NSRP #0349
May 1992

P-52 Balloting of Hull
and
Mechanical Standards

Panel SP-6

PROJECT P-52
STATUS SUMMARY
5/28/92

FIGURE 1
TYPE I LADDER ELEVATION

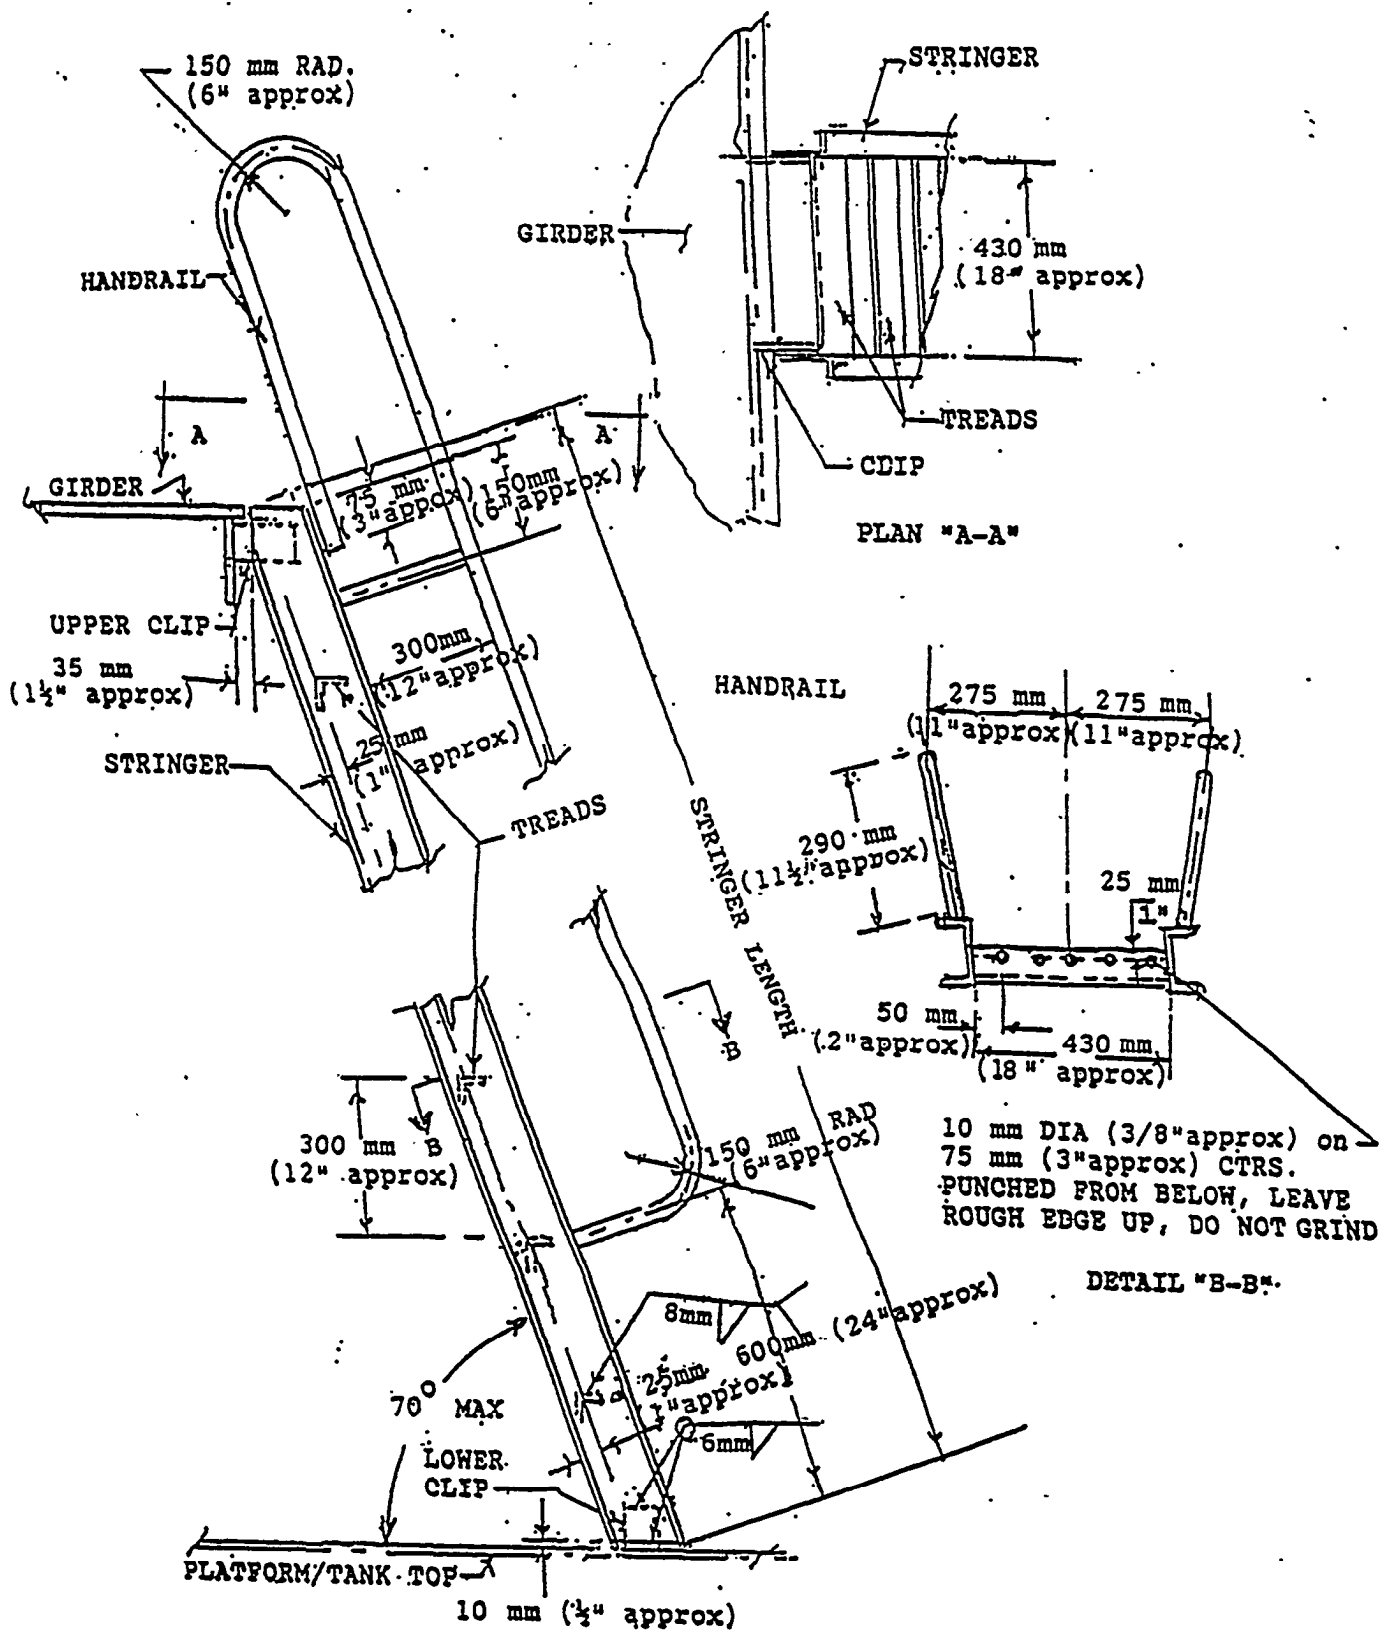
6. Fig.1 & Para 6 - Why is the tread width shown in detail A-A different from that in Detail B-8 & Para 6?

Concur - Revised, see A-A & B-B of Fig.1.
